Bulletin: TMIB-0210

Subject: Reman Transmissions Assembled Without Splitter Snap Ring

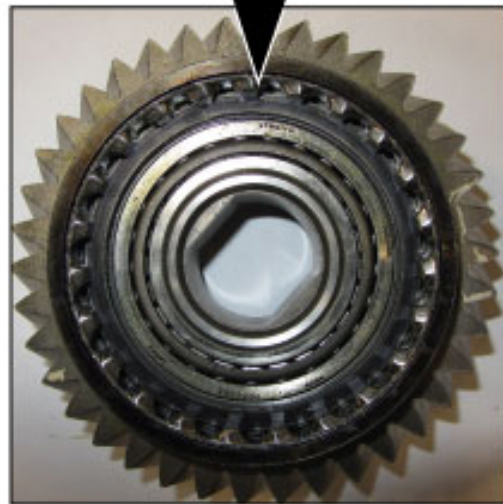
Issue Description: A number of Reman transmissions have failed due to not installing the splitter gear snap ring (4303424).

**Splitter Snap Ring - Missing**

**Splitter Snap Ring - Installed**

Eaton stocking locations have been contained but most transmissions have made it to customer locations. A corrective action was implemented on January 10, 2012 to prevent this failure in the future.

Field Strategy: Fix as fails if installed or proactively repair if not installed.
